**Intel 450KX/GX PCIset
Specification Update
82454KX/GX (PB)
82453KX/GX (MC)
82452KX/GX (DP)
82451KX/GX (MIC)**

Release Date: August 1998

Order Number: 243109-015

3. CMOS Overshoot/Undershoot Specification

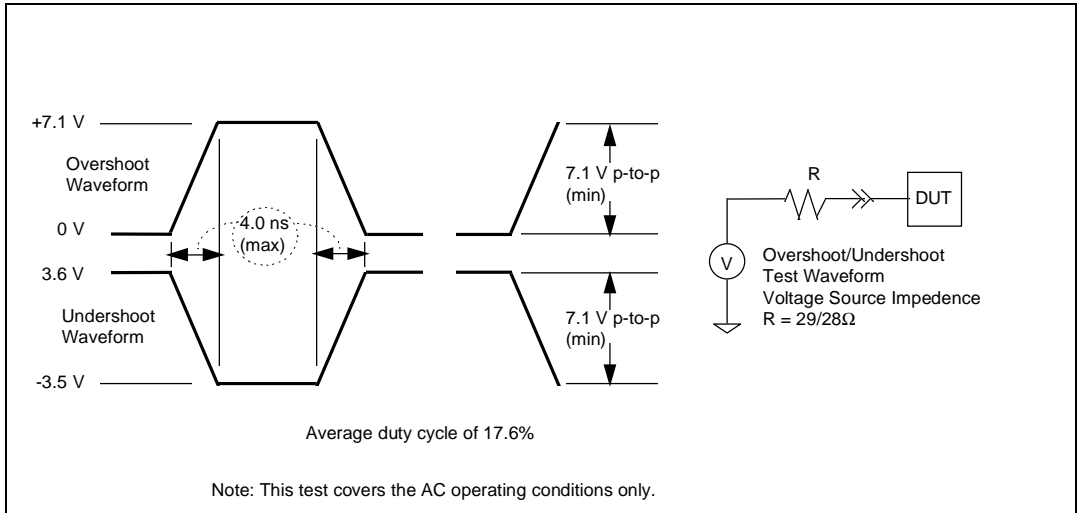
The following will be added to Chapter 4, Section 2.4, “Intel 450KX/GX Undershoot Specification,” in the *Intel 450KX/GX PCIsset* datasheet, and the section will be retitled “Intel 450KX/GX Overshoot/Undershoot Specifications.”

The 3.3 V tolerant CMOS signals of the processor bus allow for the following maximum AC waveforms:

6. ***Inbound Write Posting May Cause Write Failure***

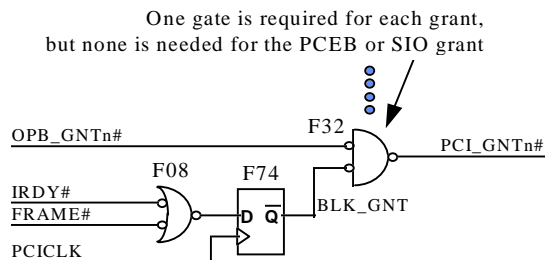
PROBLEM: During an inbound posted write burst, the 82454 PB may use the same data buffer for two adjacent transactions. This causes the first write to use and deallocate the data from the second write, corrupting data

and incorrectly deallocating a data buffer. When the data phase for the second write arrives, DBSY# may be asserted for some time, with no data phase or DRDY# assertion. When the PCI master completes the write burst, the deallocated buffer is never rewritten, resulting in a system hang with DBSY# asserted.

IMPLICATION: Enabling inbound write posting may cause data corruption followed by a system hang. Disabling inbound write posting may result in significant I/O performance loss.

WORKAROUND: An external arbiter should be implemented which allows inbound posting to be enabled, and guarantees at least two idle cycles between inbound PCI requests.

This arbiter must not perform overlapped arbitration. One way to ensure this is to implement the circuit described below, external to the arbiter. The actual workaround involves waiting for a bus idle before allowing a new grant to be issued. The IOQ depth must still be set to 1, and 2:1 interleaving must be used, to work around other errata which may surface when inbound write posting is enabled (even with this workaround). Note that this latter restriction requires at least 4 SIMM DRAM modules to be loaded at all times.

This following circuit is an implementation of the described workaround:

This workaround will allow inbound write posting to be enabled on A2 450KX PCIsset silicon, and will not affect the functionality of B0 450KX/GX PCIsset silicon, though a slight performance loss may result if this workaround is used with the B0 stepping. Enabling inbound posting by using this workaround is a significant performance enhancement for systems with A2 450KX PCIsset silicon; refer to Intel's World Wide Web site for more details on the performance loss incurred by disabling inbound write posting (at URL <http://www.intel.com/procs/support/ppro/82450.htm>).

Figure 1. V_{CC} Increase vs. T_{CASE} Drop for DPLL Failure (Worst Case)

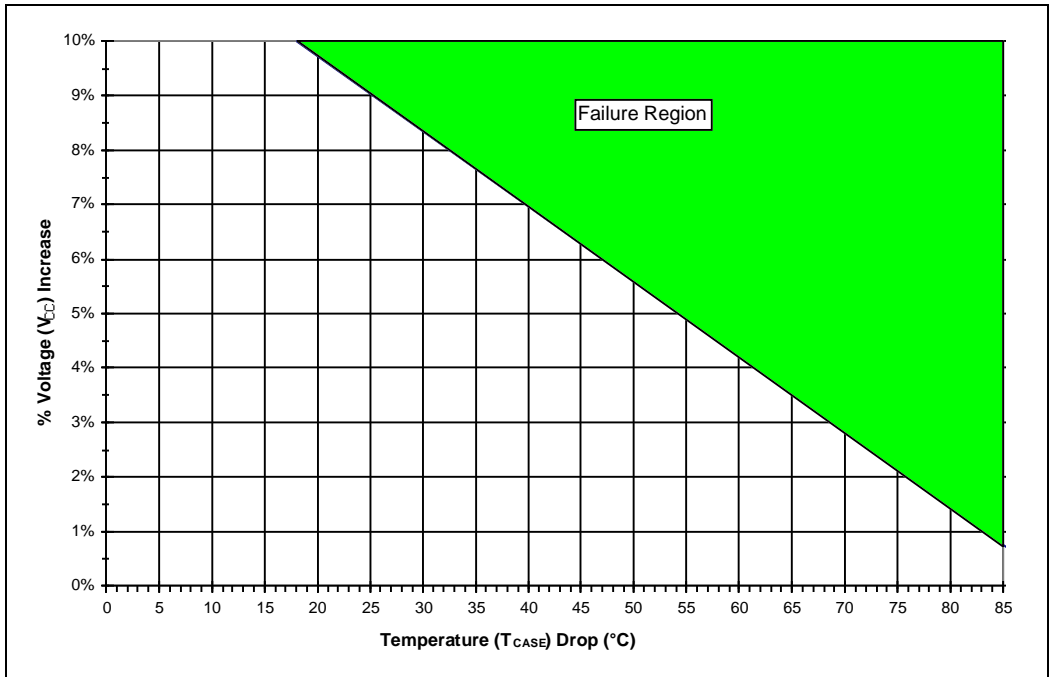
The current specification states that the Intel 450KX/ PCIsset is operational over a T_{CASE} range of 0 - 85 °C and a V_{CC} range of 3.3 V ± 5%.

After a device has undergone a hard reset of the DPLL (via the PLLRST pin), a drop in T_{CASE} accompanied by an increase in V_{CC} may cause this erratum to occur. The magnitude of the temperature drop and supply voltage increase required to cause this failure is graphed below:

IMPLICATION: If the T_{CASE} of any Intel 450KX PCIsset component is allowed to decrease by more than 18°C after the point at which DPLL lock is obtained after a DPLL hard reset, a positive voltage swing may cause the component to lose its internal clock for 2 - 500 processor bus clocks. This may result in a system hang, lost data, or other unpredictable system failure (note that if the component is not processing commands or data for the time during which the internal clock is lost, no failure will be observed). The larger the temperature drop and/or voltage swing, the more likely the failure.

3. CMOS Overshoot/Undershoot Specification

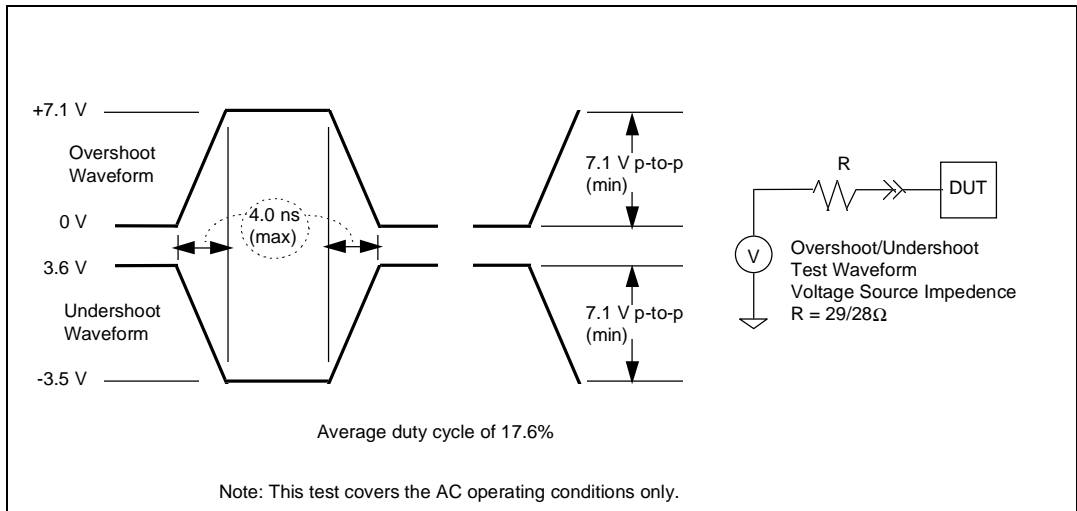
The following will be added to Chapter 4, Section 2.4, “Intel 450KX/GX Undershoot Specification,” in the *Intel 450KX/GX PCISSET* datasheet, and the section will be retitled “Intel 450KX/GX Overshoot/Undershoot Specifications.”

The 3.3 V tolerant CMOS signals of the processor bus allow for the following maximum AC waveforms:

Figure 1. V_{CC} Increase vs. T_{CASE} Drop for DPLL Failure (Worst Case)

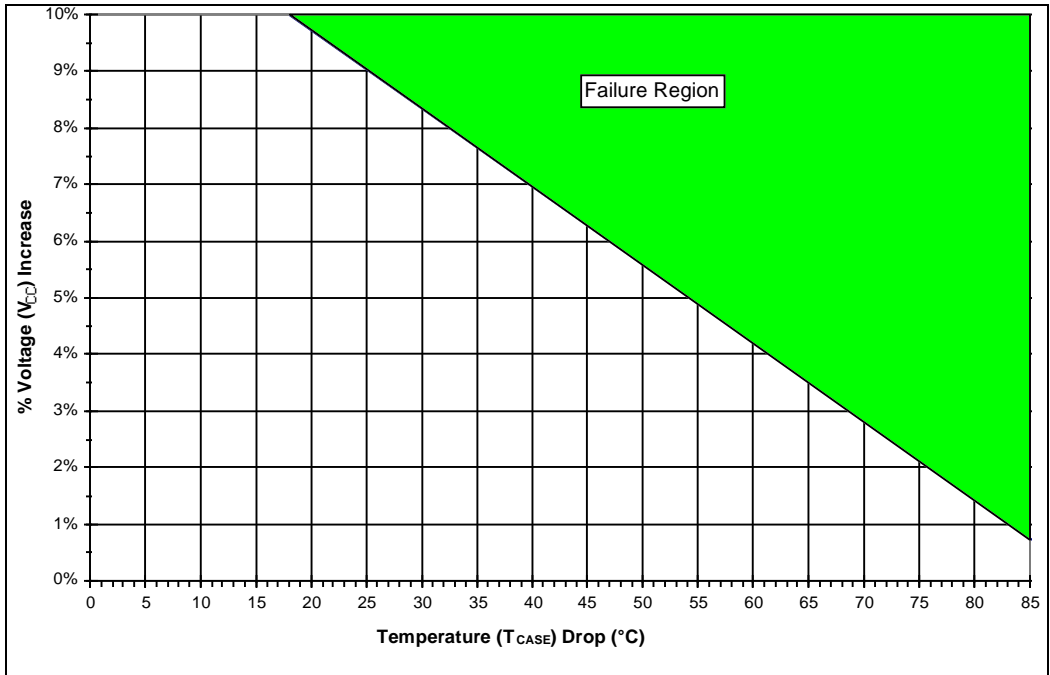
The current specification states that the Intel 450GX PCIsset is operational over a T_{CASE} range of 0 - 85 °C and a V_{CC} range of 3.3 V ± 5%.

After a device has undergone a hard reset of the DPLL (via the PLLRST pin), a drop in T_{CASE} accompanied by an increase in V_{CC} may cause this erratum to occur. The magnitude of the temperature drop and supply voltage increase required to cause this failure is graphed below:

IMPLICATION: If the T_{CASE} of any Intel 450GX PCISSET component is allowed to decrease by more than 18 °C after the point at which DPLL lock is obtained after a DPLL hard reset, a positive voltage swing may cause the component to lose its internal clock for 2 - 500 processor bus clocks. This may result in a system hang, lost data, or other unpredictable system failure (note that if the component is not processing commands or data for the time during which the internal clock is lost, no failure will be observed). The larger the temperature drop and/or voltage swing, the more likely the failure.
